**UNITED NUCLEAR**  
C O R P O R A T I O N

SUBJECT: Amendment to SNM-33: Increased Storage Capacity of  
Building 235

**501. BUILDING 235 (REFERENCE DRAWING 3712-204)**

FIGURE 26

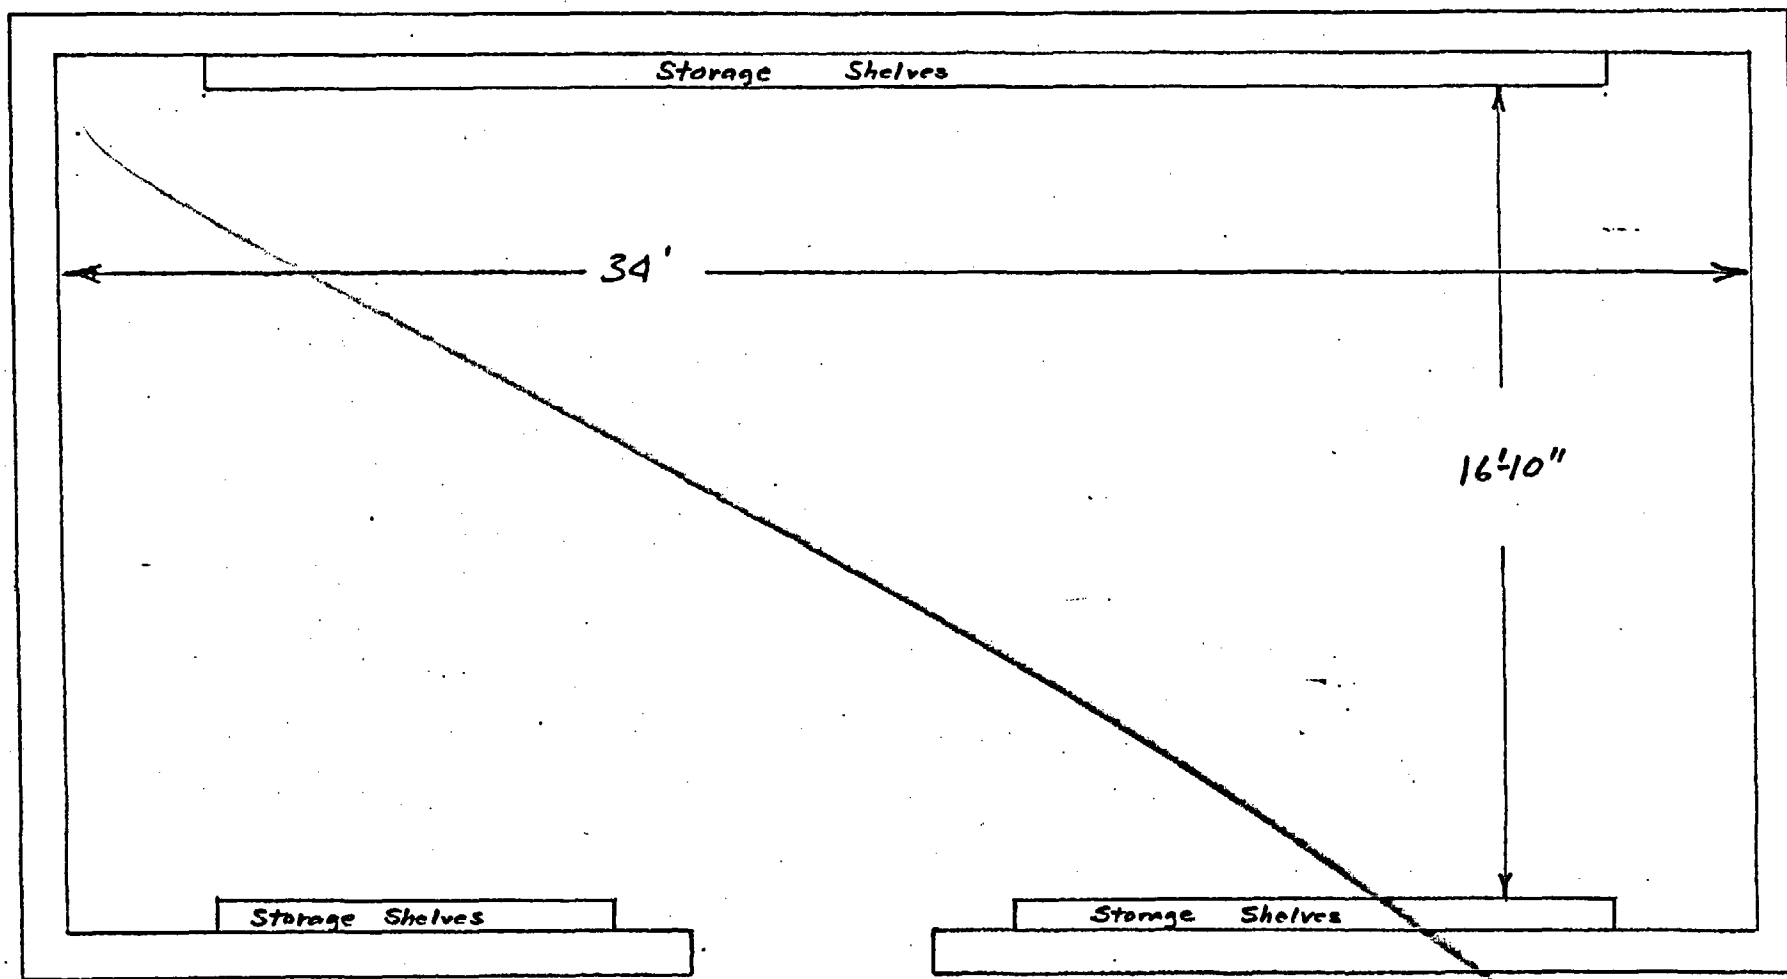
We have planned additional storage for Building 235 of our plant at Hematite, Missouri. This is to be accomplished by the addition of two concrete walls to the building. Details of this are described in Section 501, revised July 17, 1964 of "General Information Applicable to the Handling of Special Nuclear Material." A copy of this revised section is enclosed.

FIGURES 26 AND 27 SHOW A PLAN VIEW OF THIS BUILDING AND THE ARRANGEMENT OF STORAGE SHELVES. THE CONTAINER SIZES AND QUANTITIES STORED THEREIN ARE THE SAME AS LISTED IN PARAGRAPH 301.4.2. THE TOP TWO SHELVES WILL BE USED FOR THE STORAGE OF THE SHORTER CONTAINERS ONLY SUCH THAT THERE IS AT LEAST EIGHT INCHES SEPARATION TOP TO BOTTOM OF THE CONTAINERS.
